**CITY OF SAINT PAUL
HERITAGE PRESERVATION COMMISSION STAFF REPORT**

FILE NAME: 1812 Summit Avenue
DATE OF APPLICATION: September 25, 2015
APPLICANT: Ashley Mitlyng, Sicora Design/Build
OWNER: Robert Redenbaugh
DATE OF HEARING: October 22, 2015
HPC SITE/DISTRICT: Summit Avenue West Heritage Preservation District
CATEGORY: Contributing
CLASSIFICATION: Building Permit
STAFF INVESTIGATION AND REPORT: Allison Suhan
DATE: October 13, 2015

B. PROPOSED CHANGES:

MAIN FLOOR PLAN

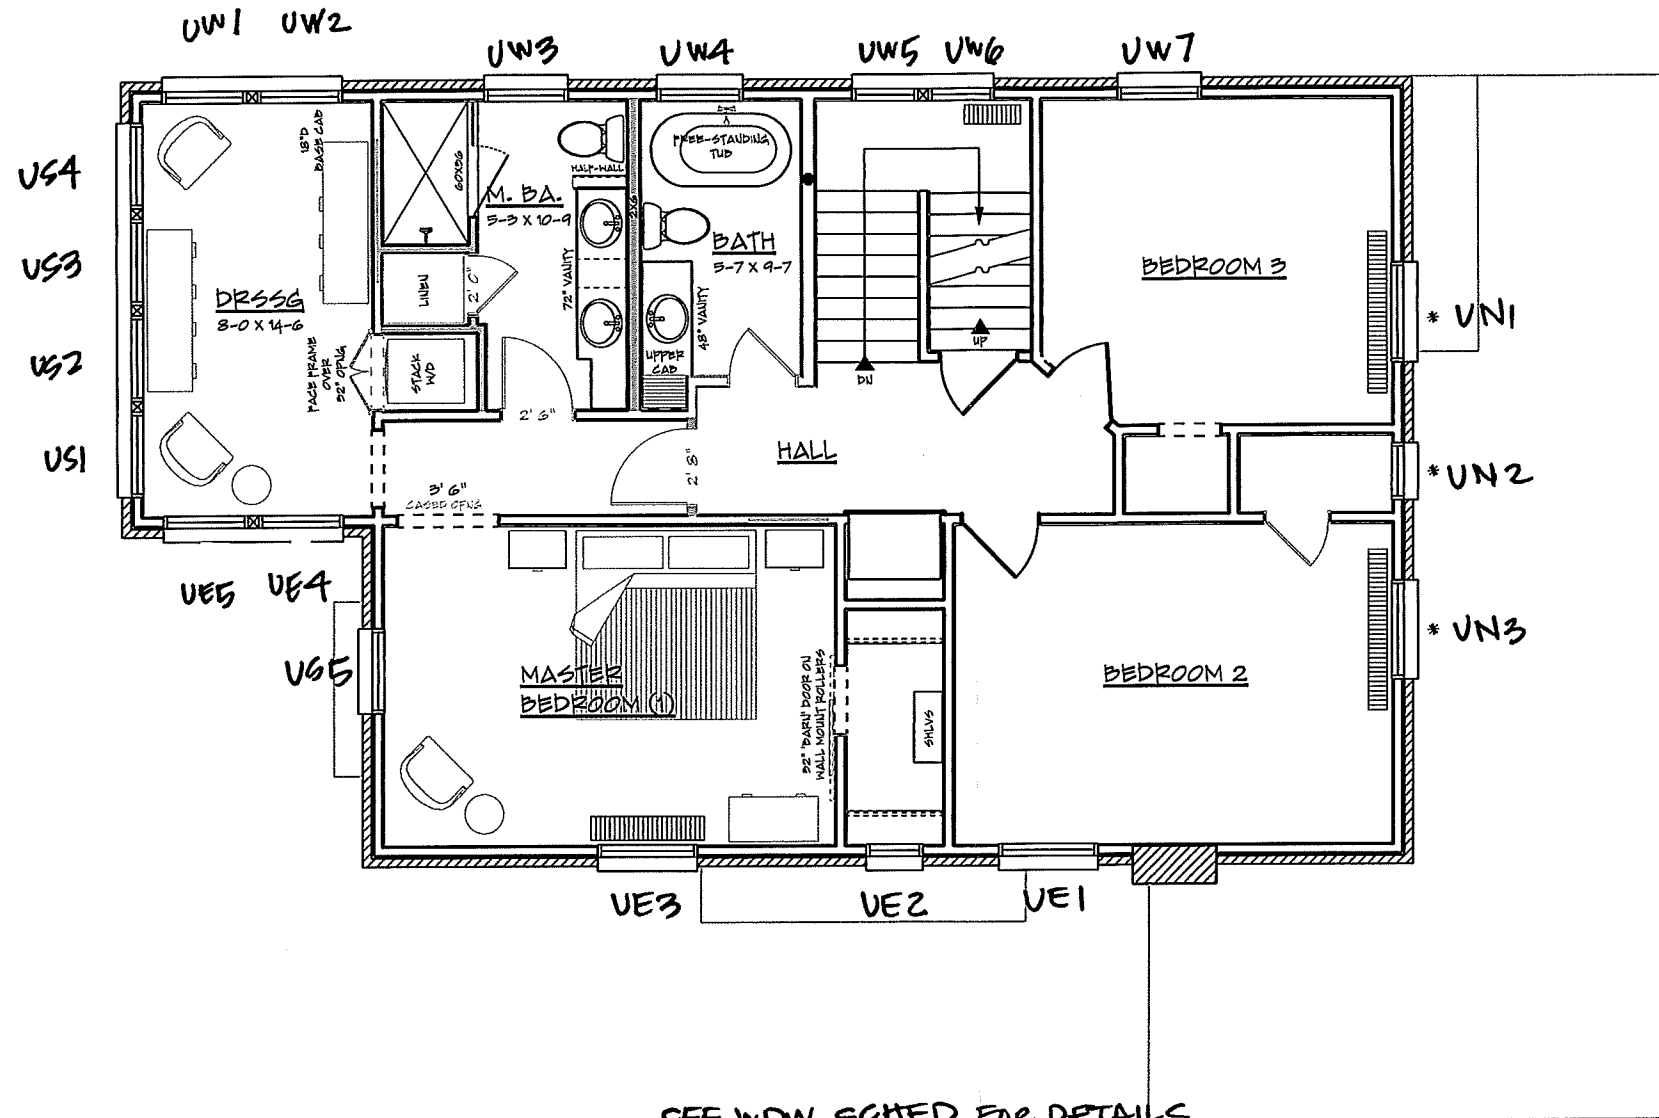
4. Sec. 74.36 (a)(2) General principle 2 states *"deteriorated architectural features should be repaired rather than replaced whenever possible"* and *"In the event of replacement, new materials should match the original in composition, design, color, texture and appearance."* Only five of the 36 proposed window openings do not have the original storms. The applicant notes that the existing storms have chipping paint and rot at the storm sill. The proposal to repair or replace the historic storms on the front façade in-kind complies with this guideline. The replacement of the secondary elevation storms with aluminum combination storm windows does not match the original in composition, design, texture, and appearance and does not comply with the guideline.

1. The historic storm windows on the front elevation, dining room bay on the east elevation, and the second floor rear porch shall be repaired or replaced in-kind (matching material, size, profile, and detail).

EXTERIOR
ELEVATIONS

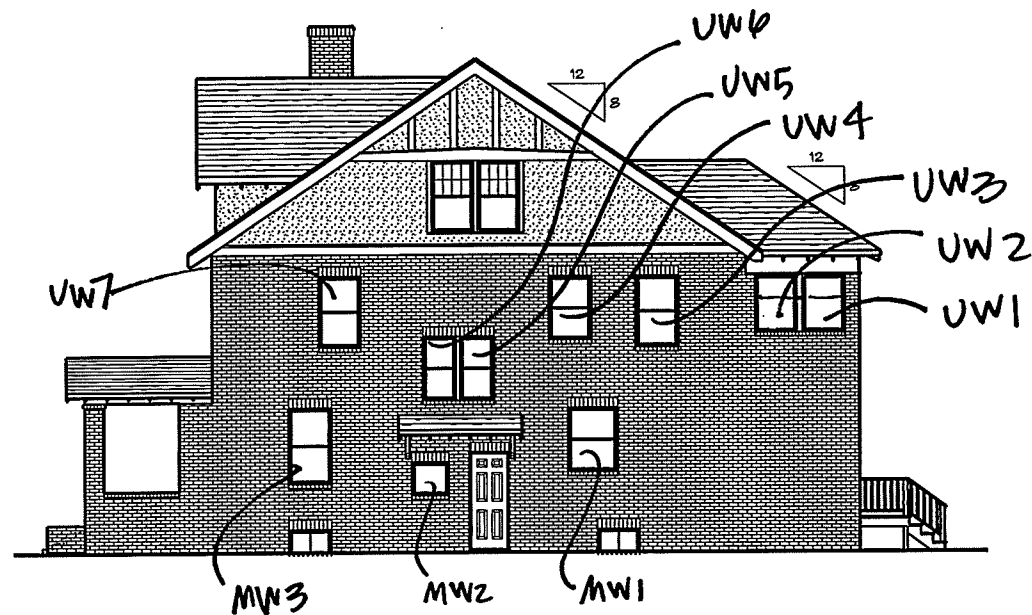
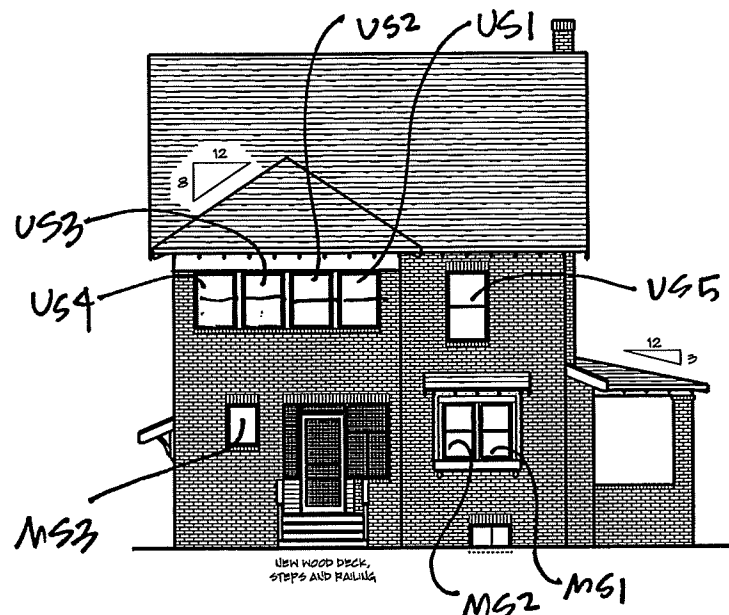
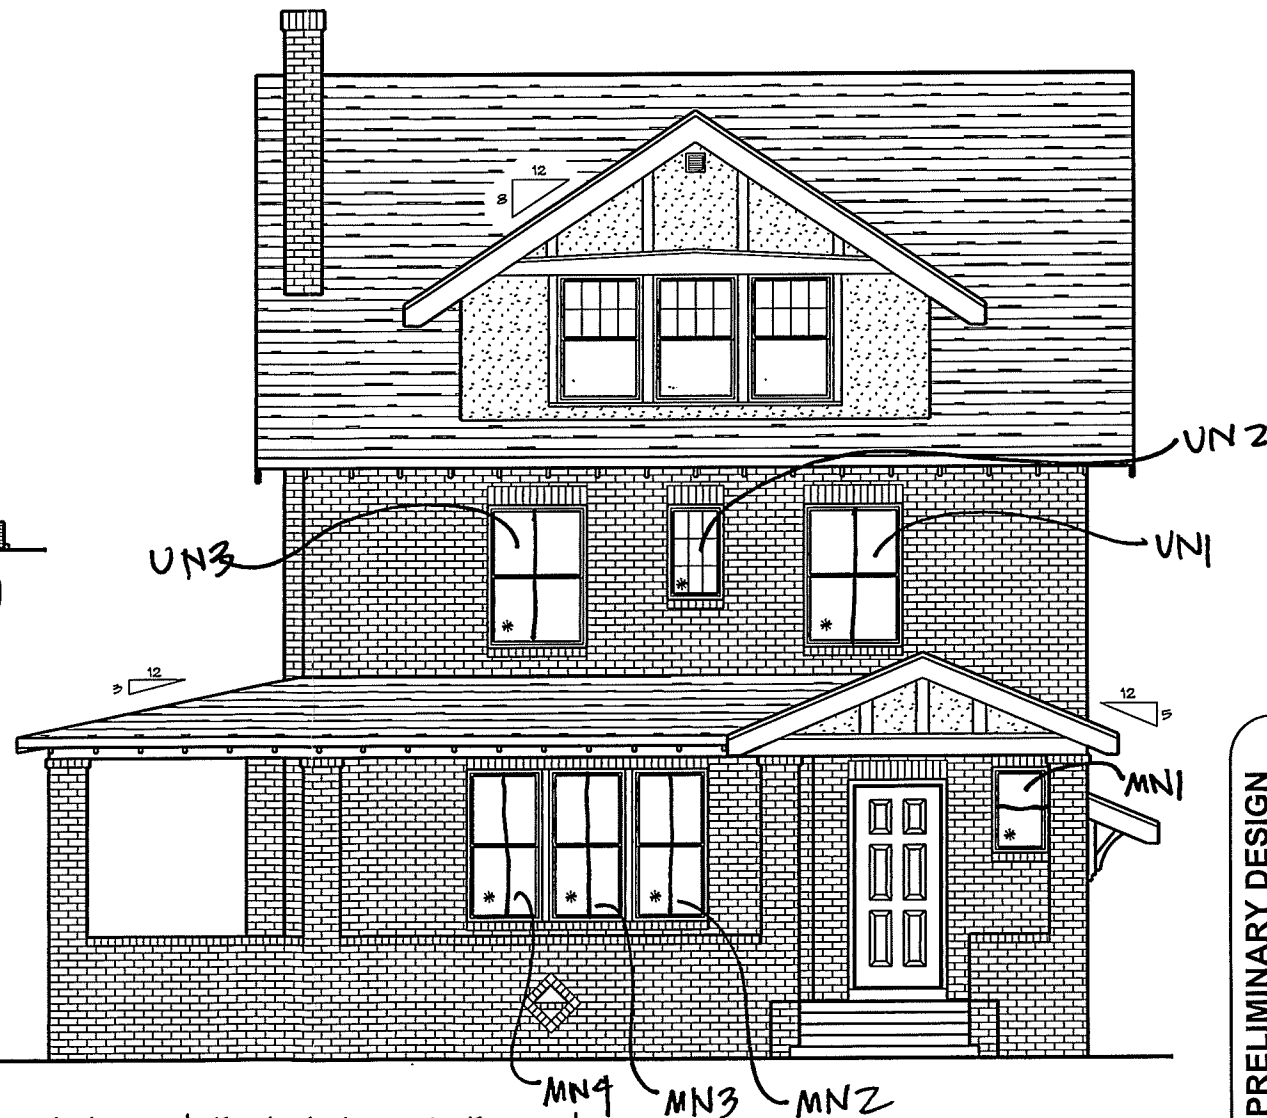
2. The house and garage are categorized as contributing to the Summit Avenue West Heritage Preservation District.
3. Sec. 74.36 (a)(1) General principle 1 states that *"the removal or alteration of distinctive architectural features should be avoided."* The original storm windows on this property are considered distinctive architectural contributing features of the property. The removal of the original storm windows does not comply with this guideline.

5. Sec. 74.36 (d)(3) The guidelines for storms/screens states *"Inappropriate new window...features such as aluminum storm and screen window combinations...that disturb the character and appearance of the building should not be used"* and *"Combination storm windows should have wood frames or be painted to match trim colors."* The fixed windows retain their historic storm windows. If replacement is necessary, they should be fixed glass storm windows as the proposed combination storm window is not appropriate and would be inoperable. The proposed aluminum combination storm windows do not comply with this guideline.

2. The historic storm windows on the fixed windows shall be restored or replaced in-kind, as the combination storm window is not appropriate and would be inoperable on the fixed windows.

3. There shall be no wrapping or panning of the brick mold, casings, or sills.
4. New combination storm windows shall be installed in the same plane (location/setback) as the original storms and screens.
